| Well Name: SCHUMACHER      | Well Location: T30N / R10W / SEC 17 / SENE / 36.815489 / -107.900699 | County or Parish/State: SAN JUAN / NM |

Notice of Intent

| Type of Submission: Notice of Intent           | Type of Action: Plug and Abandonment |

### Notice of Intent – Plug and Abandonment

## SCHUMACHER 12E - PROPOSED WELLBORE SCHEMATIC

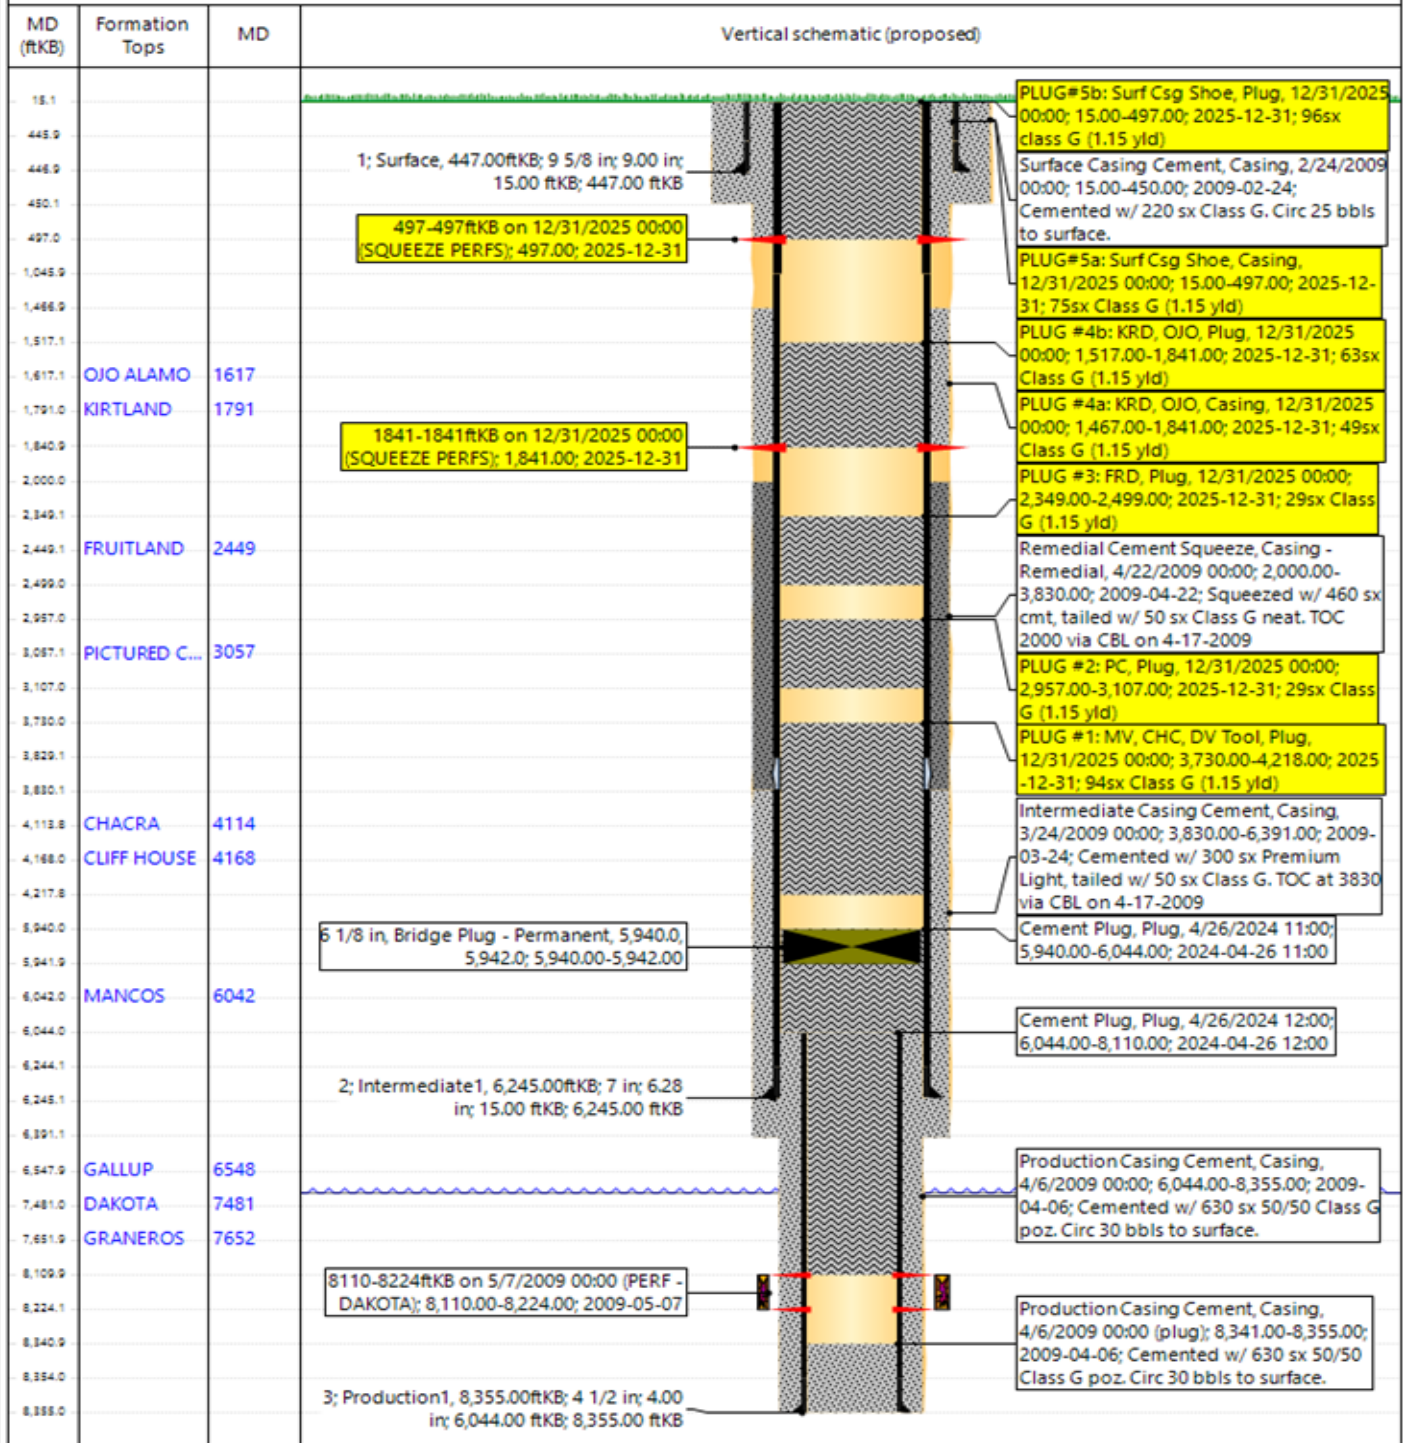
-Modify the Plug 1 BOC to 4783' to account for the BLM geologist's pick for the Cliff House.

-Modify the Plug 2 TOC to 2933' to account for the BLM geologist's pick for the Pictured Cliffs.

- Modify Plug 4: perf the squeeze holes at 1883', Move the outside plug TOC to 1467' and the inside TOC to 1517' to account for the BLM geologist's picks for the Kirtland and the Ojo Alamo.

-Modify Plug 5 to account for the BLM geologist's pick for the Nacimiento, perf the squeeze holes at 613'.

| Created By | Condition                                                                                                                                                                                                                                                                                                                                                                                                                                                                                                                                                         | Condition Date |
|------------|-------------------------------------------------------------------------------------------------------------------------------------------------------------------------------------------------------------------------------------------------------------------------------------------------------------------------------------------------------------------------------------------------------------------------------------------------------------------------------------------------------------------------------------------------------------------|----------------|
| mkuehling  | NMOCD agrees with BLM formation tops except - Chacra=4114 and PC=3057 - adjust plugs to accommodate both agencies- add 50 feet of cement with tag on CR at 5940 (subsequent from workover states locked up and reversed out) if cement is suppose to be there will need to be tagged - Adjust plug 4 to cover 200 feet each formation on outside and bring inside plug to 1323 (100 feet above BLM call on ojo top at 1423 - Notify NMOCD 24 hours prior to moving on - monitor string pressures daily report on subsequent - submit all logs prior to subsequent | 5/28/2025      |

1. Plugging operations authorized are subject to the attached "General Requirements for Permanent Abandonment of Wells on Federal and Indian Lease."
2. The following modification to your plugging program is to be made:
  - a. Modify the Plug 1 BOC to 4783' to account for the BLM geologist's pick for the Cliff House at 4683'.
  - b. Modify the Plug 2 TOC to 2933' to account for the BLM geologist's pick for the Pictured Cliffs at 3033'.
  - c. Modify Plug 4: perf the squeeze at 1883'. Move the outside plug TOC to 1467' and the inside TOC to 1517' to account for the BLM geologist's picks for the Kirtland at 1833' and the Ojo Alamo at 1423'.
  - d. Modify Plug 5 to account for the BLM geologist's pick for the Nacimiento at 563', perf the squeeze holes at 613'.
3. **Notification:** Farmington Office is to be notified at least 24 hours before the plugging operations commence at (505) 564 7750.
